369-377 Kentish Town Road

Design Statement

September 2024

This document sets out proposed design updates to the approved scheme at 369-377 Kentish Town Road. The original consent was for a seven story (G+6) building with 14 residential apartments, and Class E (retail) use at ground and basement floor. Planning permission was granted for the scheme in 2020 - application ref: 2019/0910/P.

2.3.1 South and East Elevation

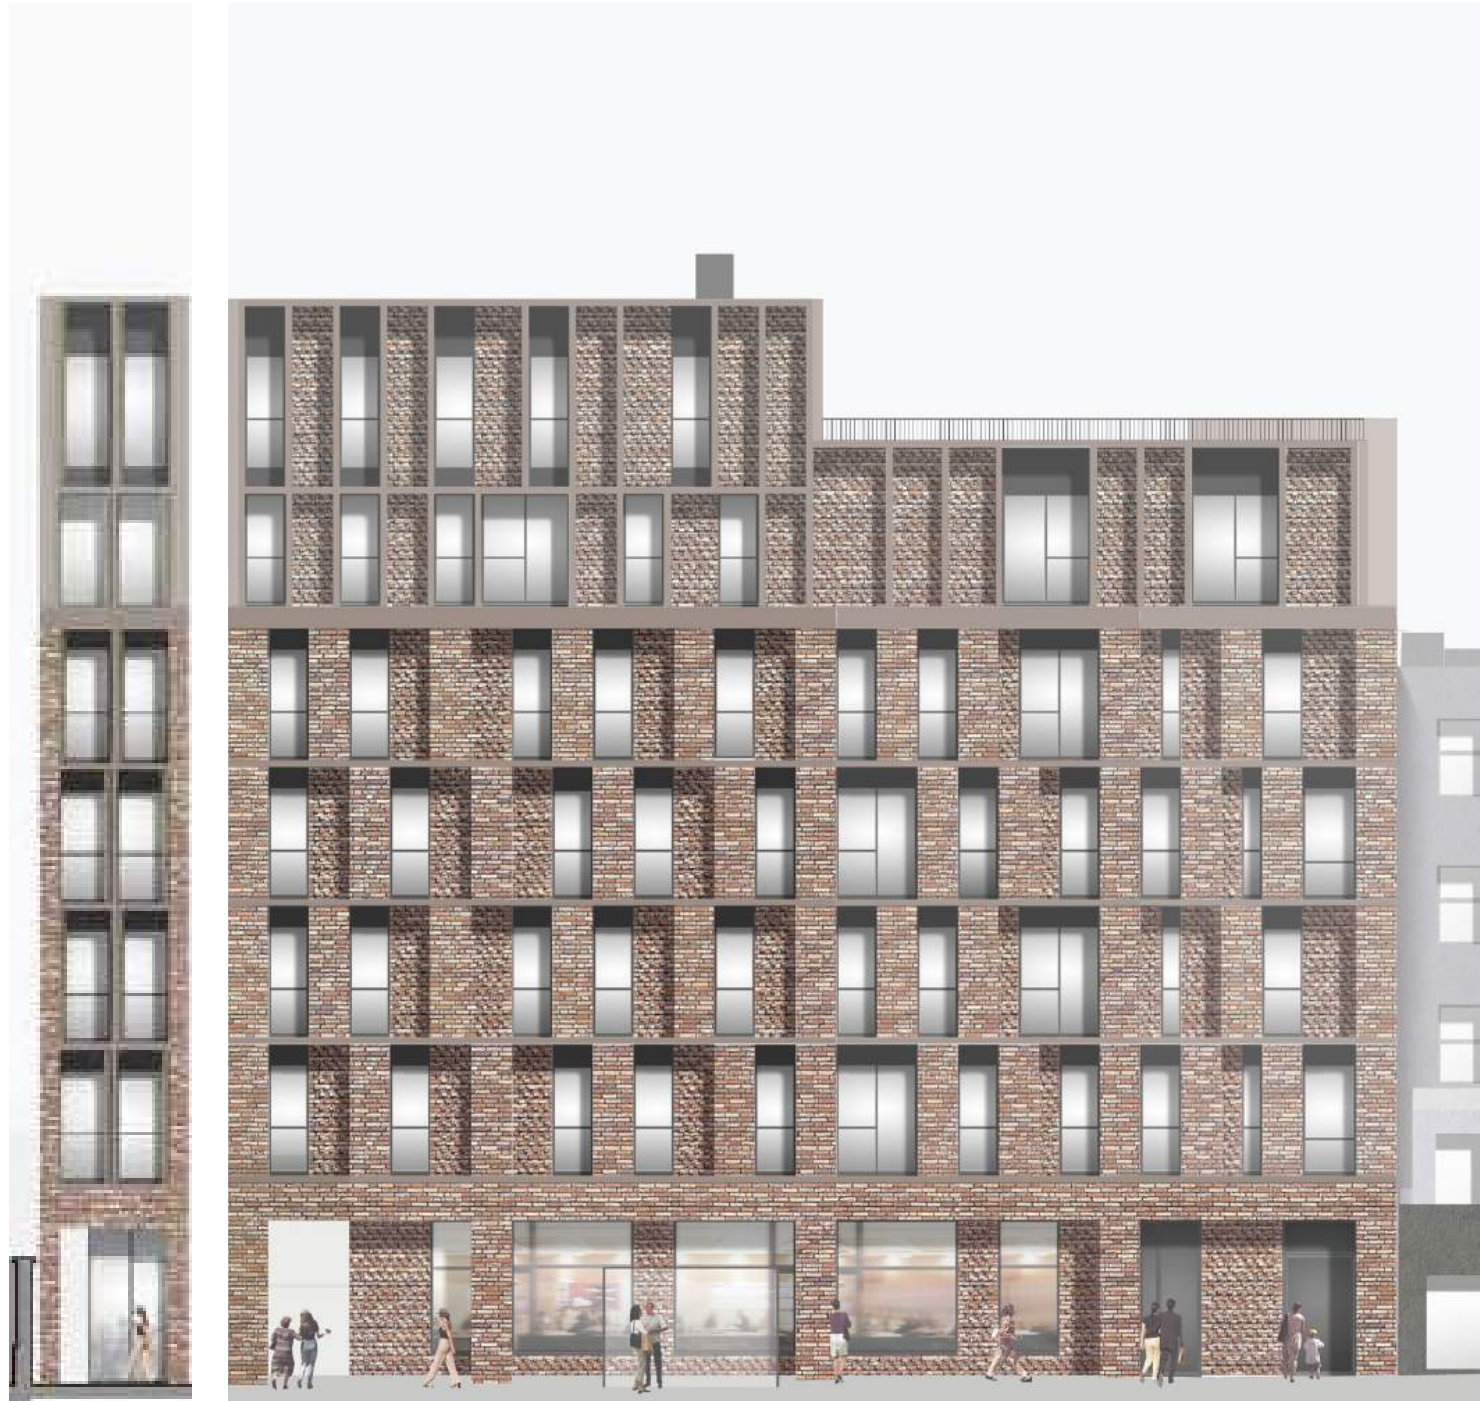
1. Reconfigured design to upper levels to strengthen rhythm of piers.
2. Raised parapet to help conceal ASHPs - not visible from street level.
3. Layout change to facade to reinforce the stepping rhythm.
4. Horizontal bands at first to fourth floor levels changed to a double vertical brick soldier course.
5. Change to 'textured' brick recessed panels to avoid drawbacks of extruded headers - refer to technical design development section for more detail.

6. Set back columns at ground floor to allow better flow around corner retail entrance.
7. Ground floor set back to emphasise the active 'plinth', reinforcing link to the context.
8. Reconfigured and set back entrance - to provide protected entrance space.
9. Shutters removed due to health and safety cleaning requirements.

West Elevation

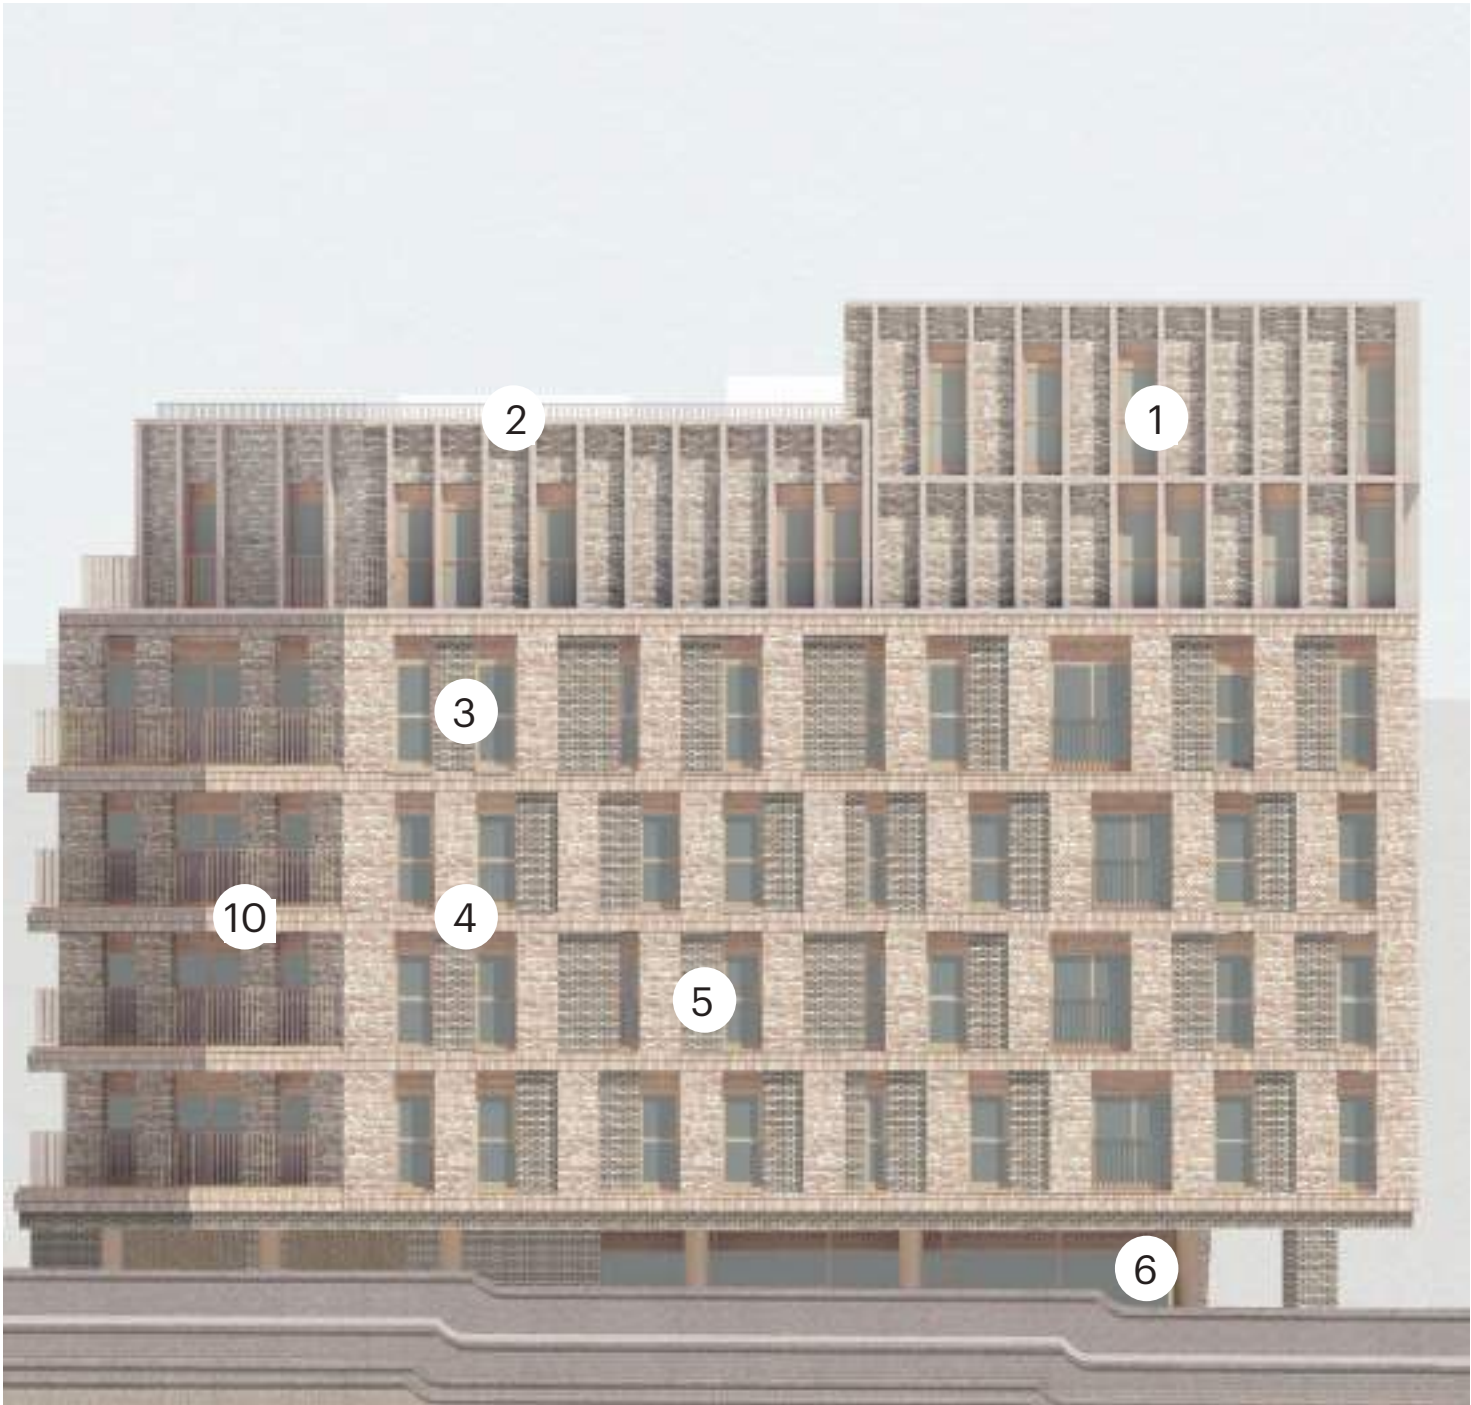
1. Reconfigured design to upper levels to strengthen rhythm of piers.

2. Raised parapet to help conceal ASHPs - not visible from street level.

3. Layout change to facade to reinforce the stepping rhythm.

4. Horizontal bands at first to fourth floor levels changed to a double vertical brick soldier course.

5. Change to 'textured' brick recessed panels to avoid drawbacks of extruded headers - refer to technical design development section for more detail.

6. Set back columns at ground floor to allow better flow around corner retail entrance.

10. Balcony layout changed to allow for cleaning and maintenance.

Ground Floor

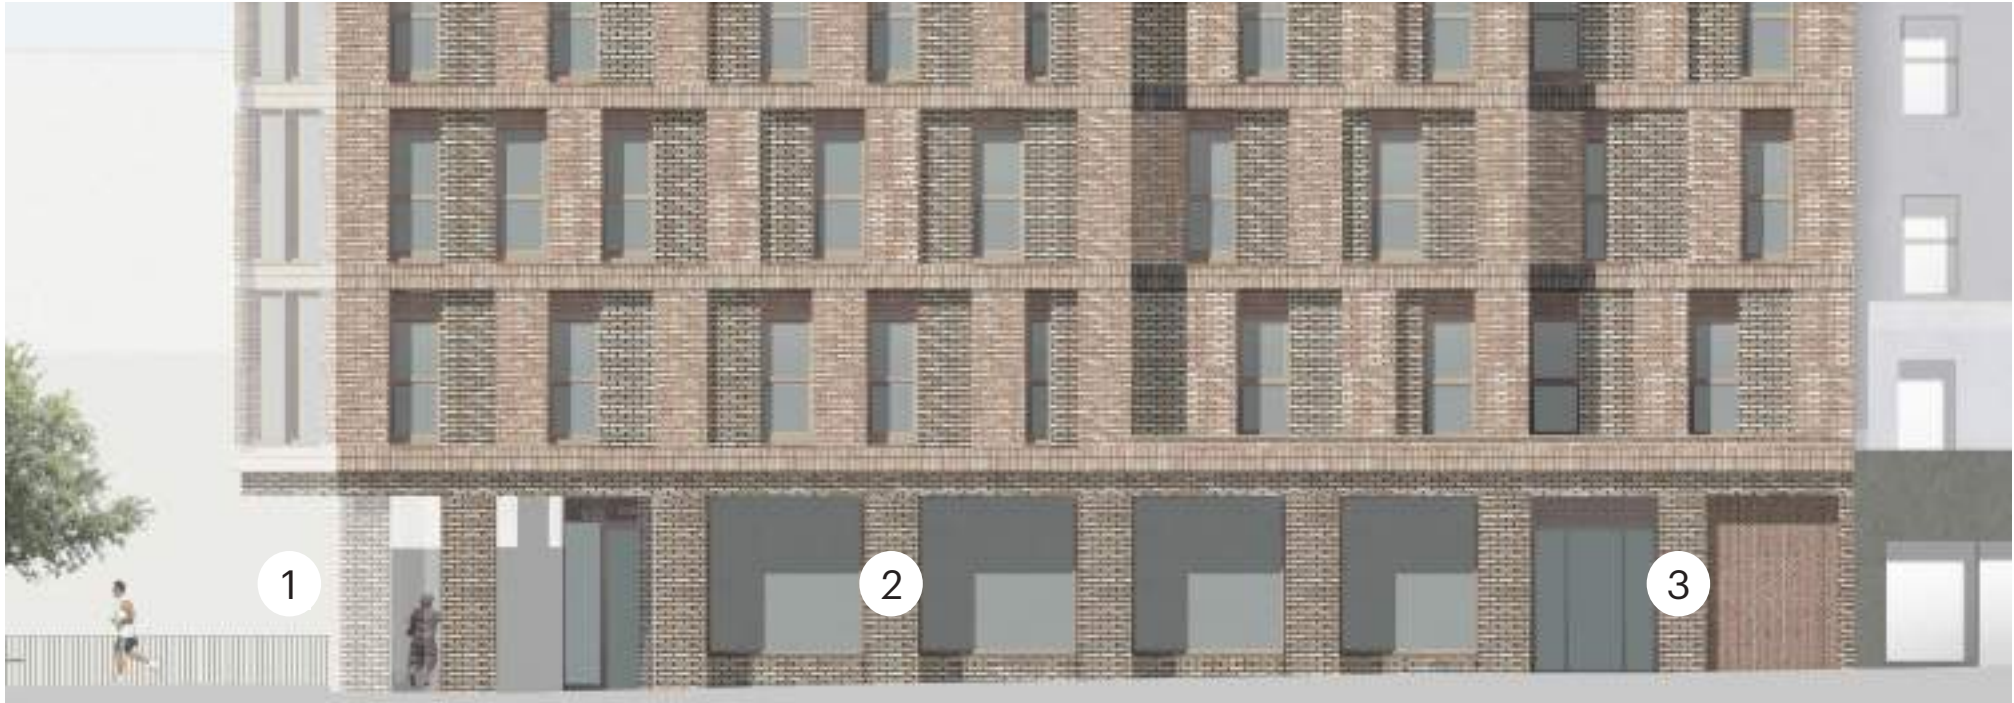
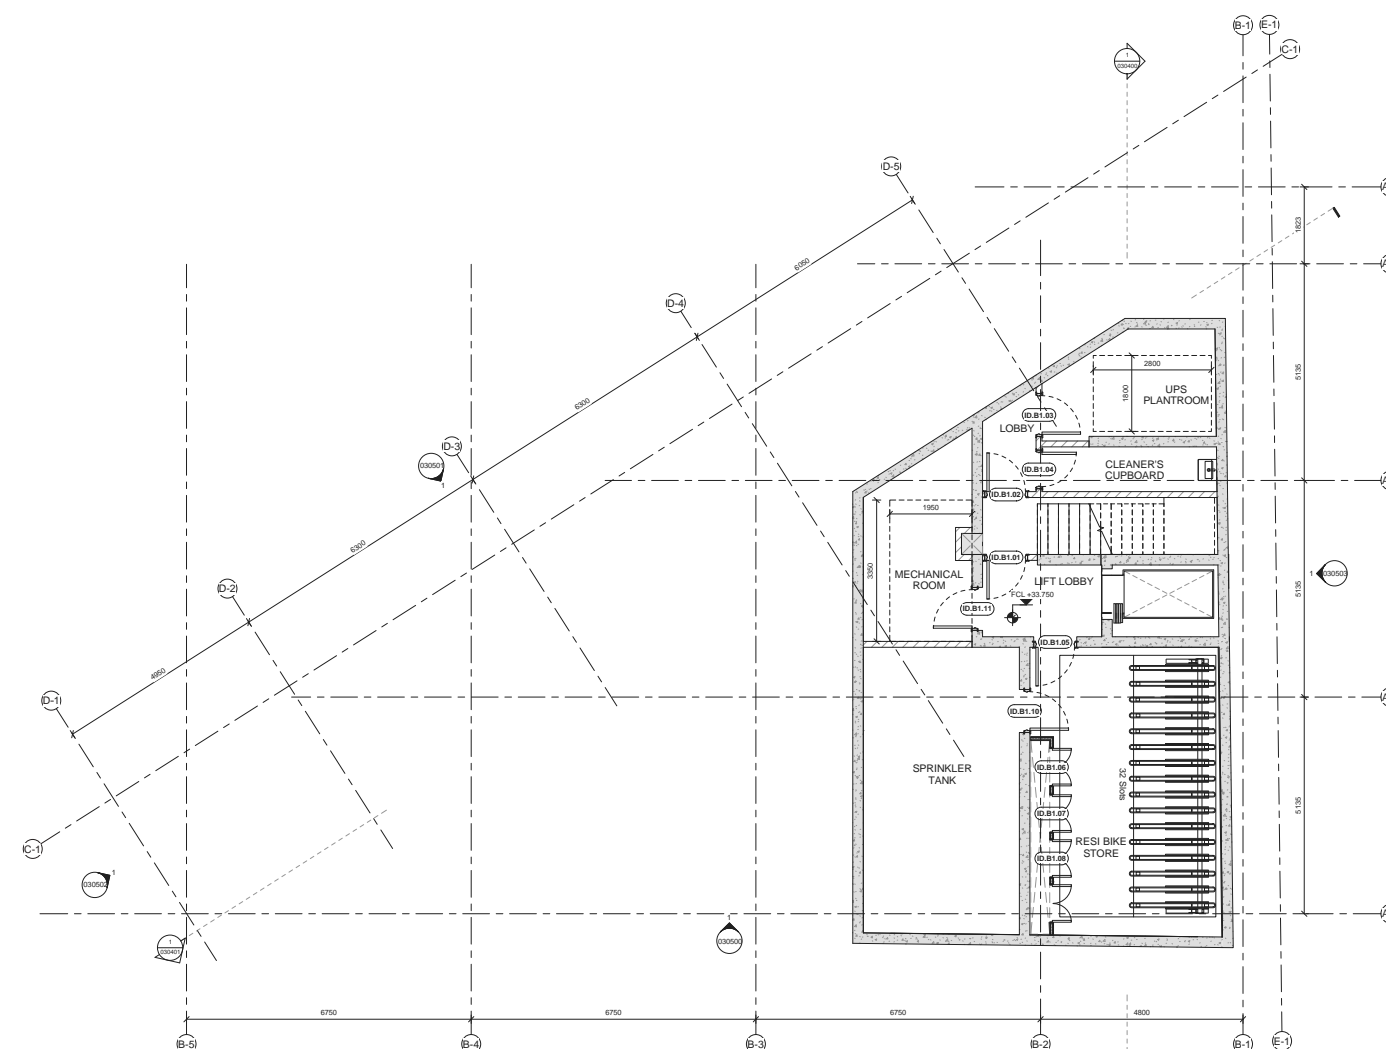
The structure has been pulled back from the edge of the building (to the left of the elevation) to allow for a better window layout on the corner. At ground floor this allows the structure to be pulled back, allowing a better flow of public space in this location.
2.

The facade is stepped back at ground floor and the
3.

brick is textured here providing a form of rustication - reinforcing the base of the building.
3.

Reconfigured entrance layout as described in the plans above.

Ground Floor Plan

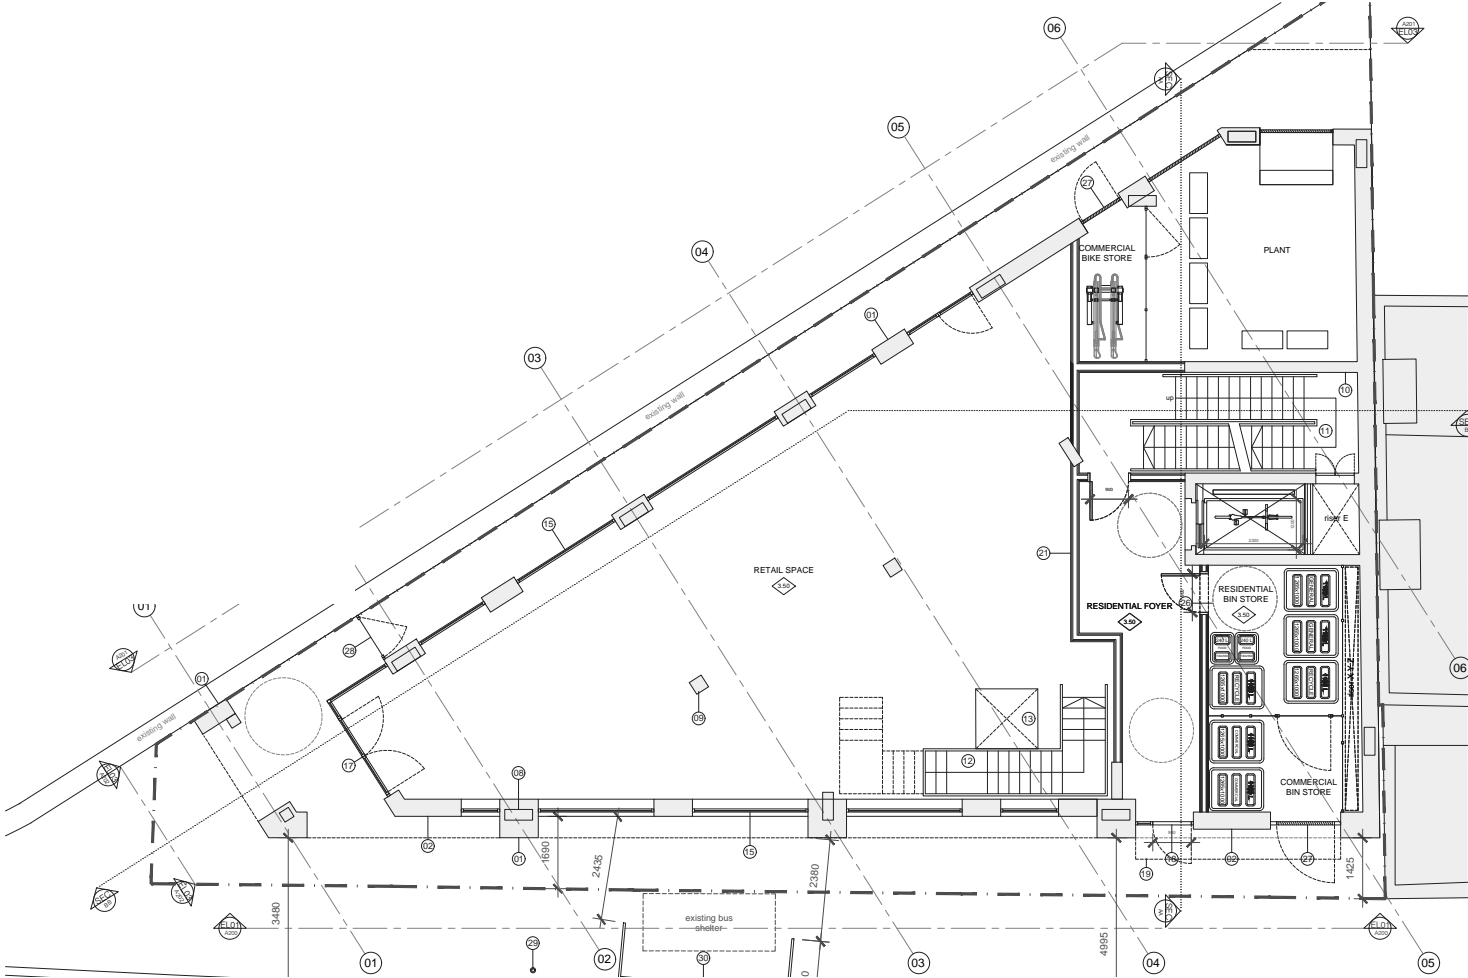
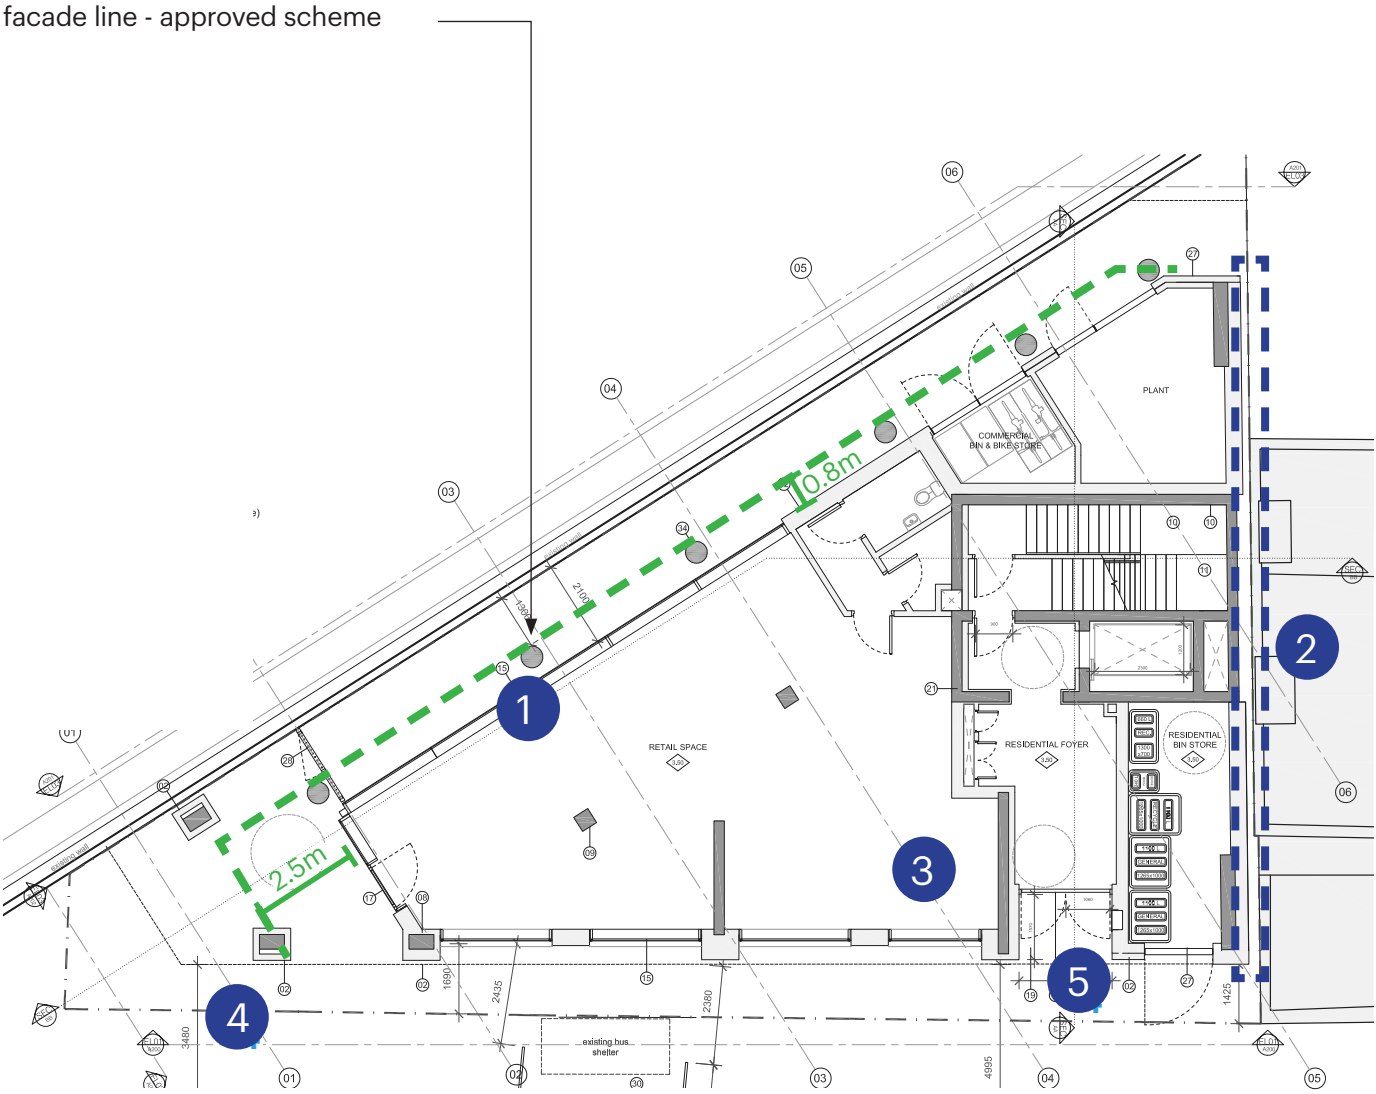
Set back of main façade to allow for public access and future Heathline walkway. 2.8m spacing of curtain wall mullions to allow for aluminium system.
2.

Party wall moved 150mm away from site boundary due to site tolerances with existing building adjacent.
3.

Escape stair from basement and lobby no longer required.
4.

Reconfigured structure to allow for better window arrangement and better public flow at the retail entrance.
5.

Entrance canopy removed, entrance recessed to allow for covered landing. Dry riser provision in side wall adjacent.
